Access Compliance Report Public Rights-of-Way (Curb Ramps)

Main Street: OLD_RANCH_RD Cross Street: BROOKHILL_DR Location: SE

ADA ID: RPAT210922083619 Ramp Type: Type 3 - Combination 1 Initial Pass/Fail: Fail Overall Compliance: No Severity Score: 4

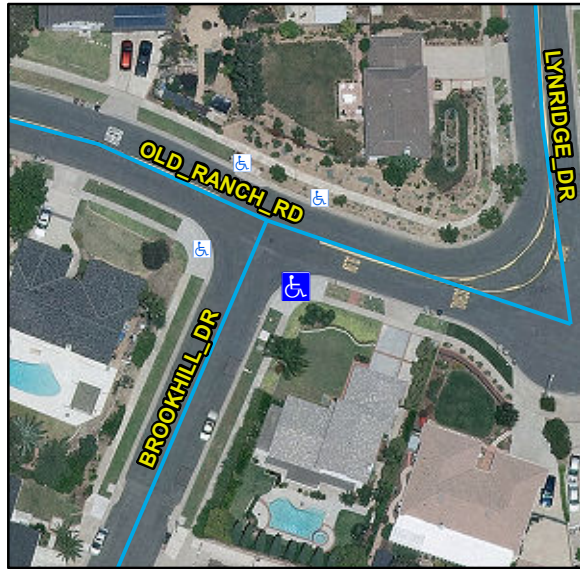
R304.2.2, R304.5.1, STD 1115

Remove & Replace Curb Ramp With Two New Directional Ramps or Equivalent. Remove & Replace Sidewalk.
